DOCUMENT 00 90 00
ADDENDUM

ADDENDUM: 1

DATE: APRIL 14, 2025

PROJECT: IOWA-GRANT SCHOOL DISTRICT
LOCKER ROOM RENOVATION
462 IOWA GRANT ROAD
LIVINGSTON, WISCONSIN 53554
PROJECT NO. 25007

1 PARTIAL SECOND FLOOR PLAN
1/8" = 1'-0"

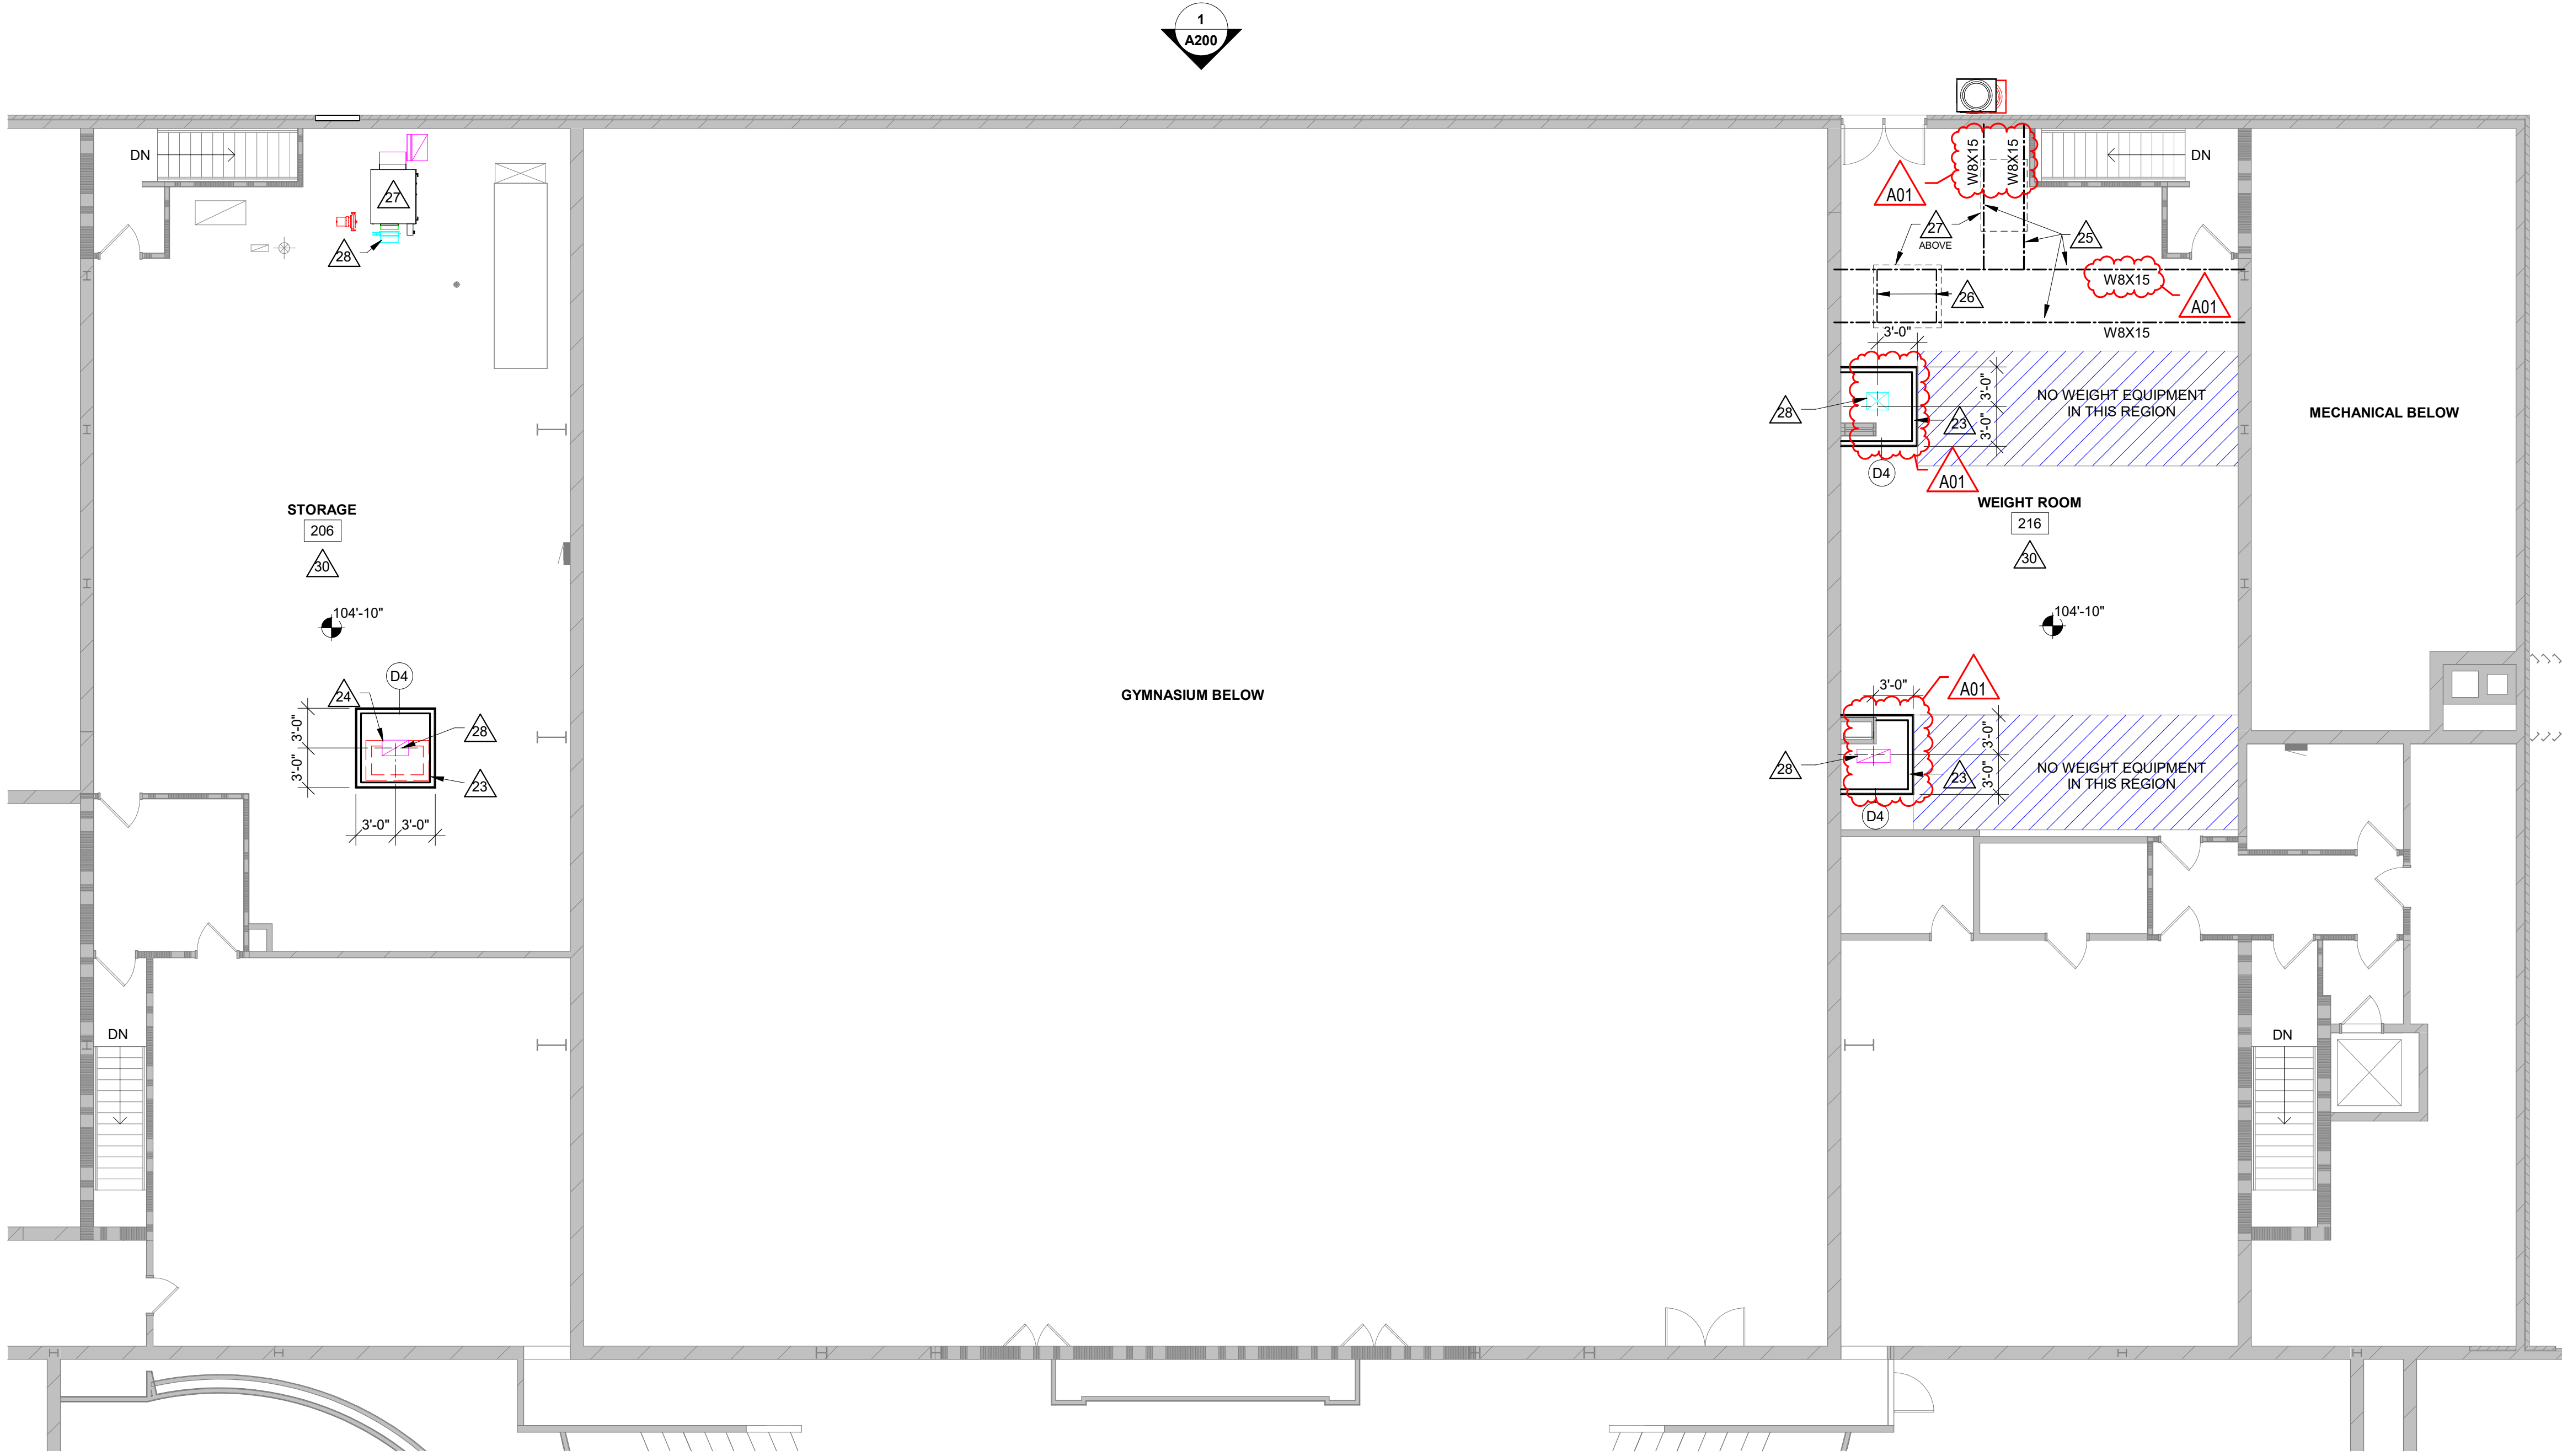
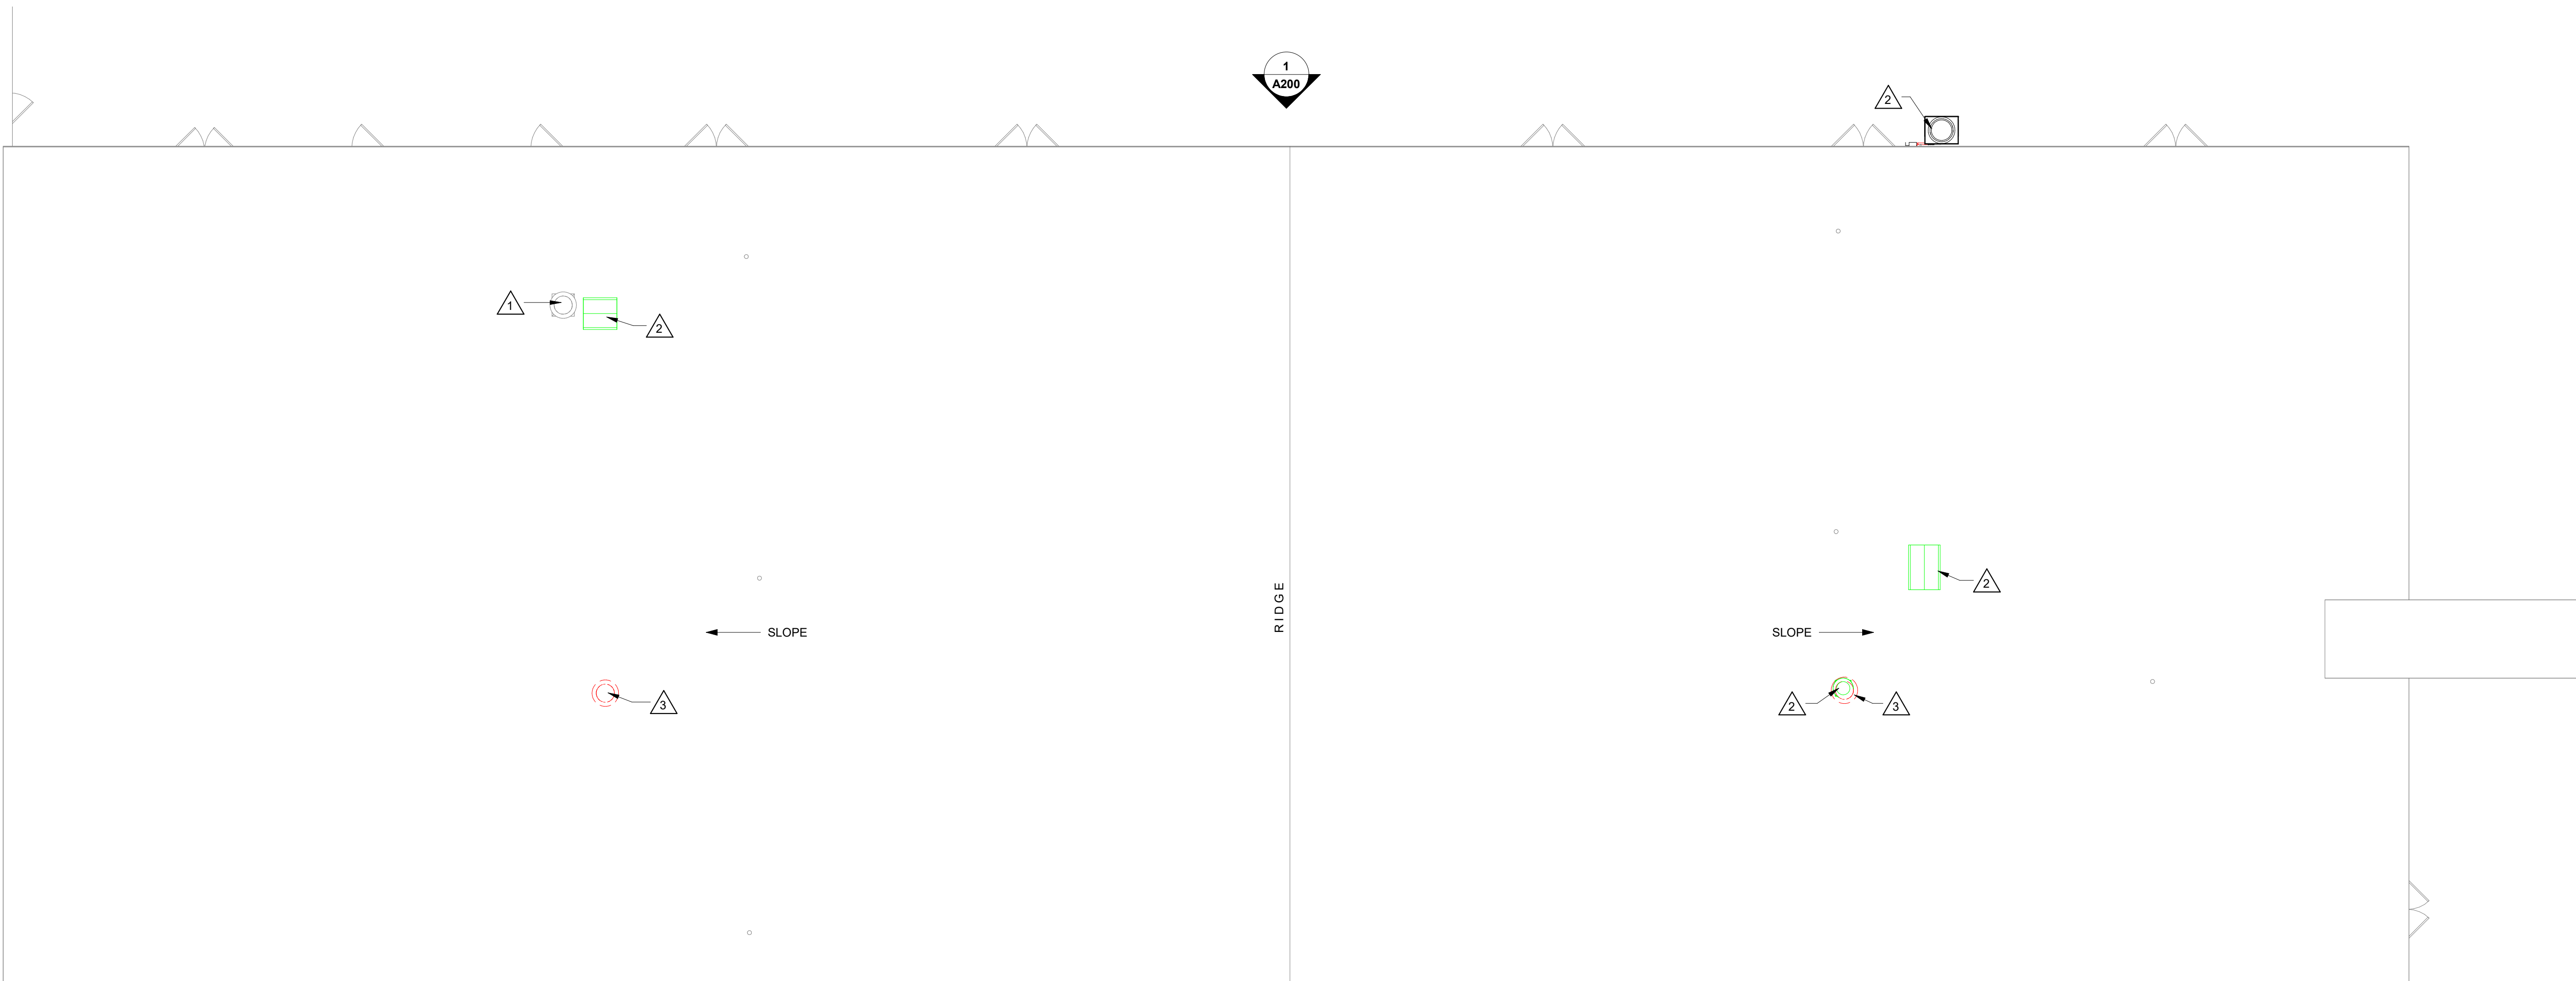
2. Sheet A100 FIRST FLOOR 30"x42"
 - a. See the revised sheet included in this addendum. Disregard the previous version.
 - b. Reversed the orientation of door 180.
3. Sheet A101 PARTIAL SECOND FLOOR, ROOF PLAN 30"x42"
 - a. See the revised sheet included in this addendum. Disregard the previous version.
 - b. Added beam size information to framing in weight room 216.
 - c. Relocated mechanical equipment penetrations through roof.
4. Sheet A110 REFLECTED CEILING PLAN 30"x42"
 - a. See the revised sheet included in this addendum. Disregard the previous version.
 - b. Revise gypsum board soffit elevations and extents.
 - c. Remove suspended ceilings from room 170 & 185.

Sheet Title: **FIRST FLOOR BG PLUMBING DEMO PLANS**

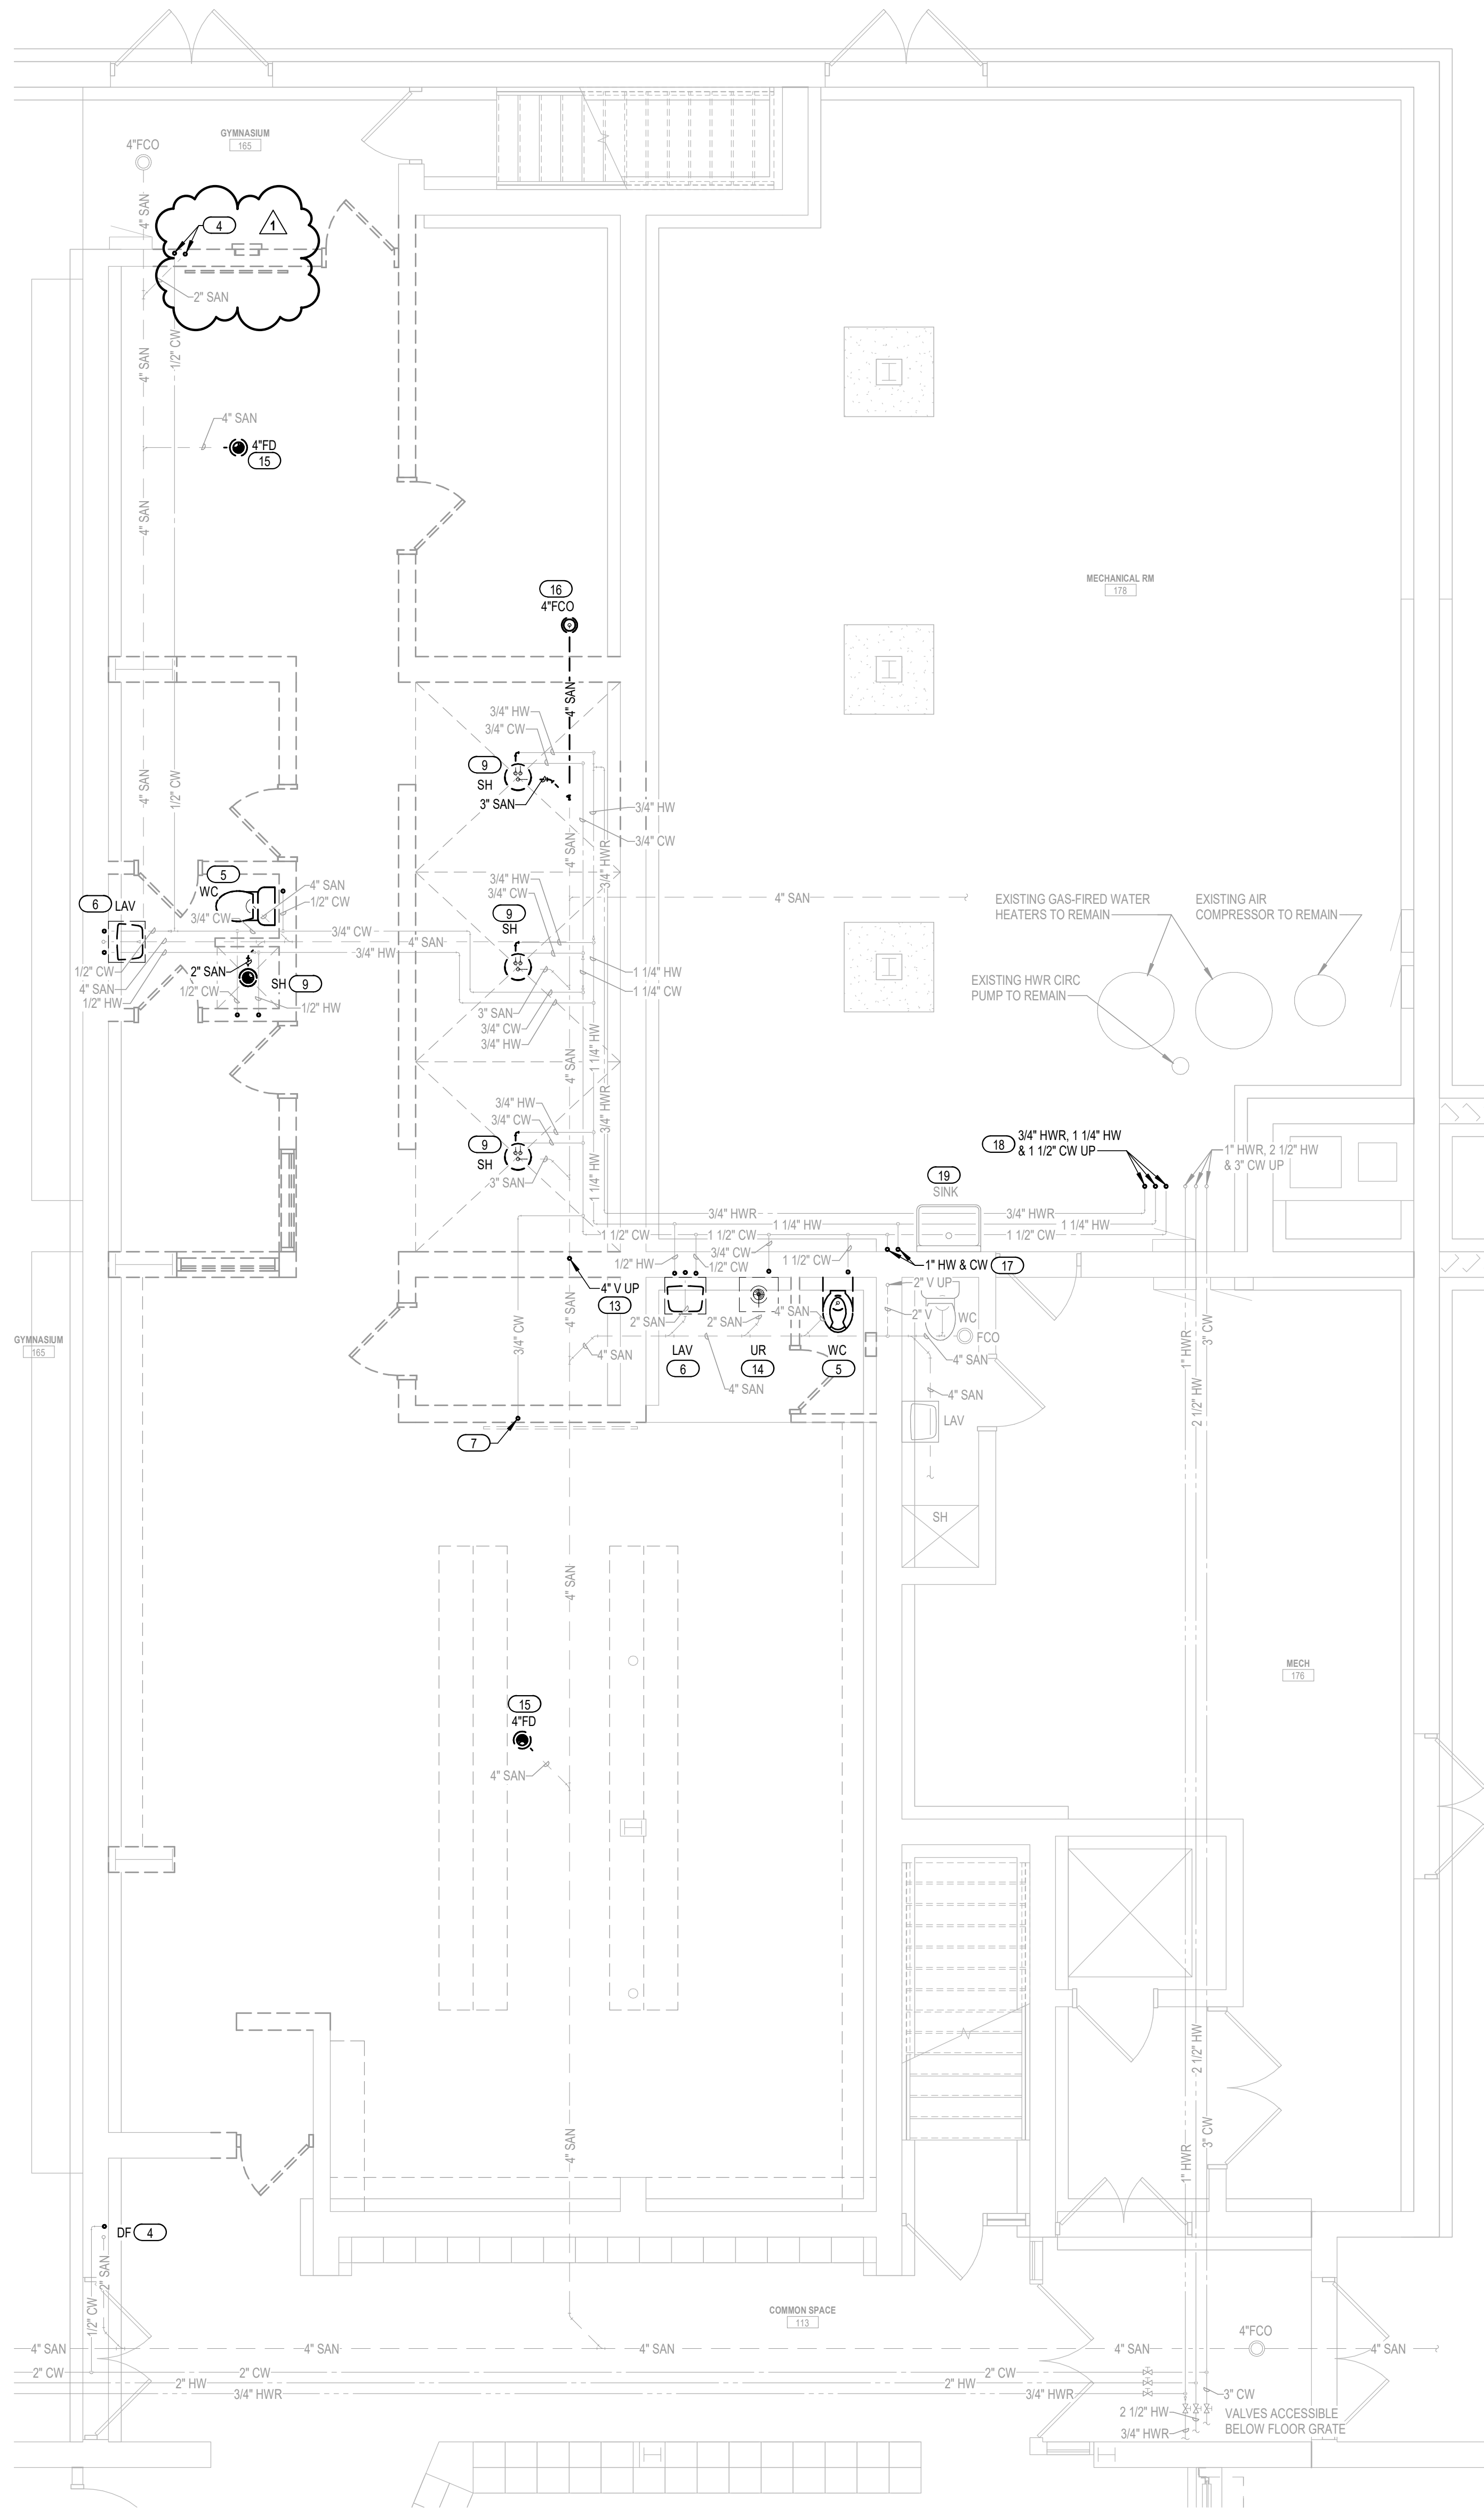
8. Sheet PD100 FIRST FLOOR BG PLUMBING DEMO PLANS 30"x42"
 - a. See the revised sheet included in this addendum. Disregard the previous version.
 - b. Revise keyed note number for demolition instructions of existing drinking fountains.
